Project	<b>IEEE 802.16 Broadband Wireless Access Working Group</b> < <a href="http://ieee802.org/16">http://ieee802.org/16</a> >	
Title	<b>Mesh mode text for 802.16ab standard</b>	
Date Submitted	2001-08-28	
Source(s)	<p>Mika Kasslin Nokia Itamerenkatu 11-13 00180 Helsinki, Finland</p> <p>Dave Beyer Nokia 313 Fairchild Dr. Mountain View, CA 94043</p>	<p>Voice: +358-718036294 Fax: +358-718036856 [mailto:mika.kasslin@nokia.com]</p> <p>Voice: +1 650 625 2294 Fax: +1 650 625 2545 [mailto:dave.beyer@nokia.com]</p>
Re:	80216ab-01_06r1	
Abstract	This paper consists of clauses describing mesh mode of 802.16ab air interface standard. Clause numbering used is from the draft under comments and the intention is to provide a comprehensive description of all related messages and functionalities. This document is not a standalone document but should be used in parallel with the related commentary file giving definite instructions.

Purpose	Adopt the text proposed to the 802.16ab-01/01 to make mesh mode description more thorough.	
Notice	This document has been prepared to assist IEEE 802.16. It is offered as a basis for discussion and is not binding on the contributing individual(s) or organizatio

Figure 1—Time Relevance of MSH-DSCH in Distributed Scheduling Mode

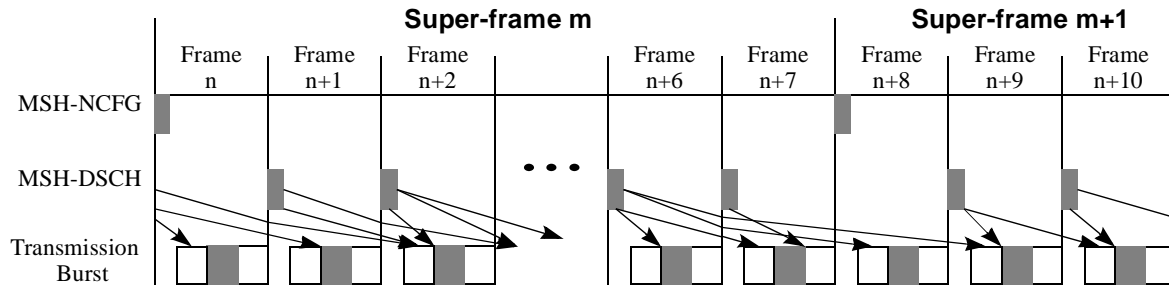
When using coordinated distributed scheduling all the stations in a network shall use the same channel to transmit schedule information in a format of specific resource requests and grants in Mesh Mode Schedule Messages with Distributed Scheduling (MSH-DSCH). A station shall indicate its own schedule by transmitting a MSH-DSCH regularly. The MSH-DSCH messages shall be transmitted during the control portion of the frame. Relevance of the MSH-DSCH is variable and entirely up to the station. An example case is given in Figure 1, in which super-frame size of eight frames has been assumed.

Figure 2—Time Relevance of MSH-CSCH in Centralized Scheduling Mode

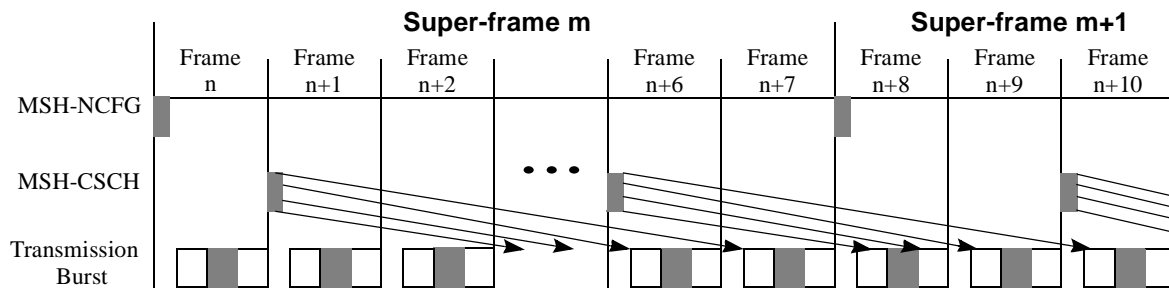
While in distributed scheduling mode all the stations within each two-hop neighborhood shall exchange their schedules in MSH-DSCH messages, in centralized scheduling mode the BS shall indicate all the SSs less than or equal to  $HR_{\text{threshold}}$  hops from the BS their schedule. BS shall use the Mesh Mode Schedule Messages with Centralized Scheduling (MSH-CSCH) message for that purpose. The MSH-CSCH shall apply to a certain fixed period called an Epoch. An Epoch consists of a variable number of frames. The number of frames in an epoch can be configured during system installation, and can occasionally adapt due to considerations like network size, but shall generally remain static during system operation. This is illustrated in Figure 2, in which an Epoch consists of four frames and a super-frame is equal to eight frames. One should note, that the figure doesn't show messages like MSH-CRQs required for the successful scheduling. Further, it's a simplified snapshot from the BS's perspective: no MSH-CSCH messages forwarded by the SSs in the network are shown in the figure.
